SUBJECT: Forwards Summary of NRC Comments re proposed program plan,
 participant listing & handouts for 850308 meeting concerning
 function & task analysis per detailed control room design
 review summary rept & SSER 7.

Subject: Palo Verde Nuclear Generating Station (PVNGS)
Units 1, 2, and 3
Docket Nos. STN 50-528(License No. NPF-34)/529/530
Task Analysis Meeting on March 8, 1985
File: 85-056-026; G.1.01.10

ATTACHMENT 1

Figure 1.

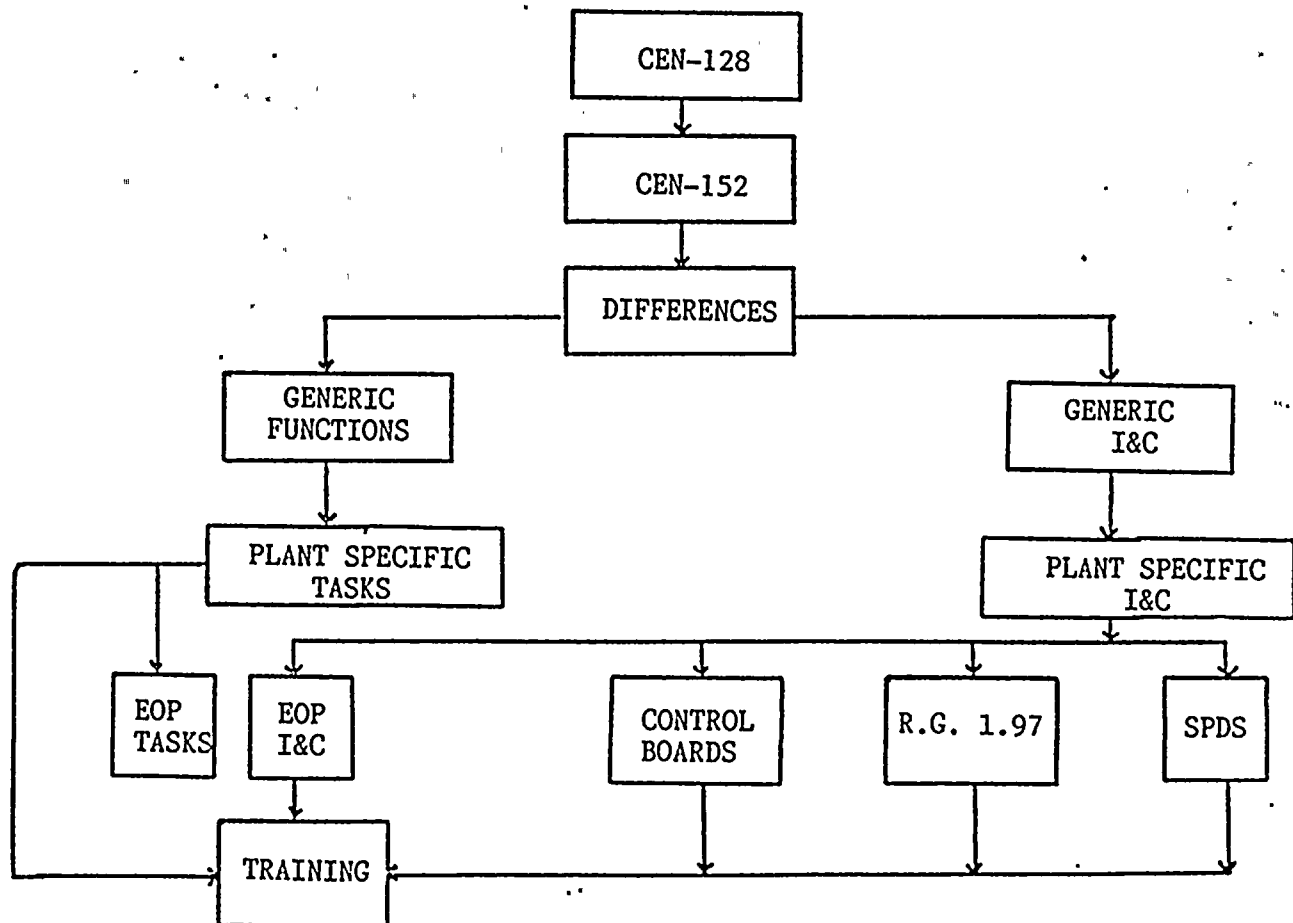
1. The task analysis must go beyond the procedural step of "VERIFY X". The "VERIFY X" step must be broken into explicit and implicit tasks.
2. Column 7 of Figure 1 (Attachment 2) - "Plant Specific Information/Controls", must be stated in terms of the "needed characteristics" for the task. The "needed characteristics" must also be stated in the same terms as the Figure 2 control room inventory of existing information/controls so that there can be a one to one comparison made.

Figure 2.

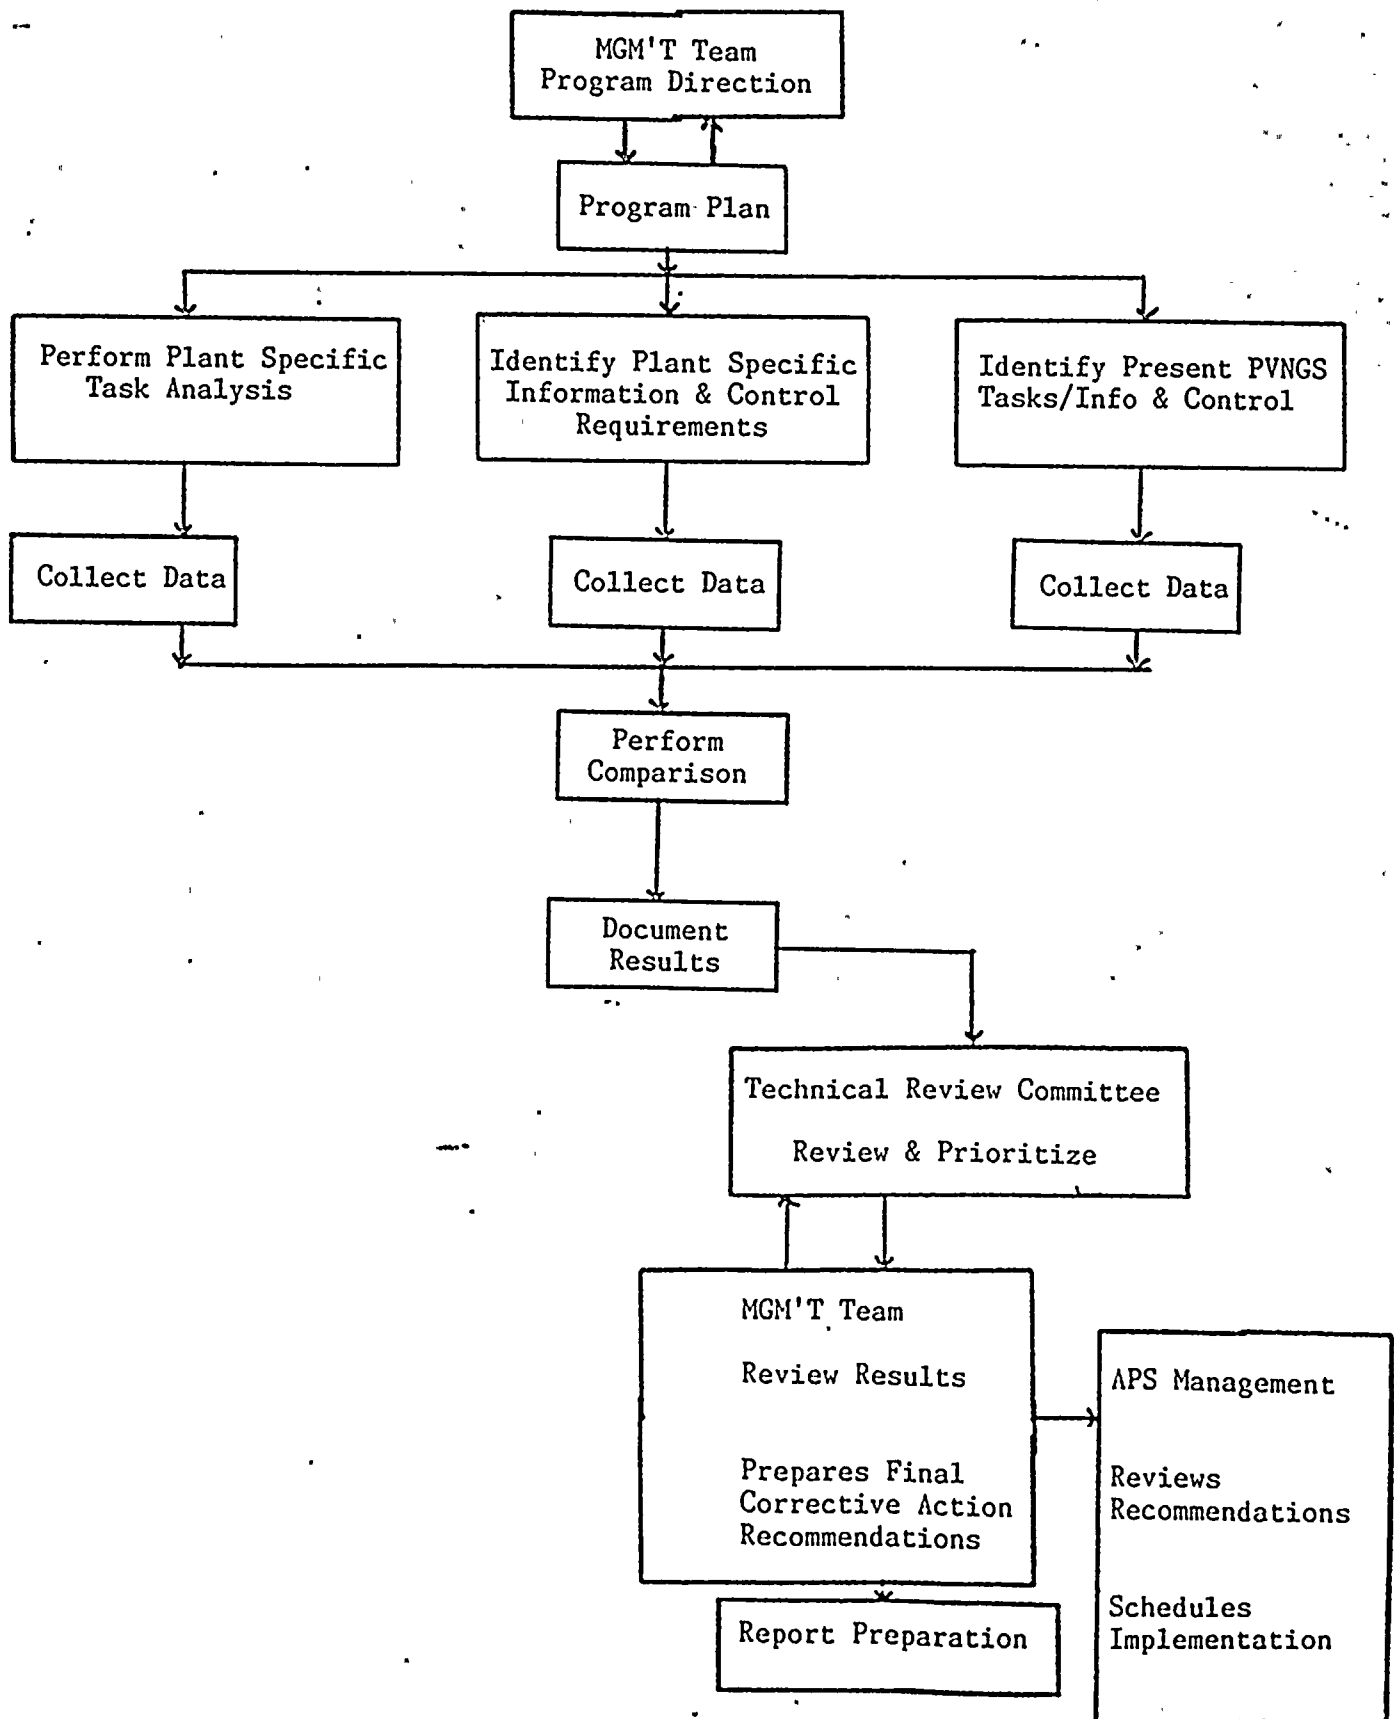
3. The control room inventory performed from plant documentation must be verified by an actual control room walkdown. It was suggested that 2 new columns be added for Figure 2 (Attachment 2): "Verified By Control Room Walkdown" and "Differences/Justification".
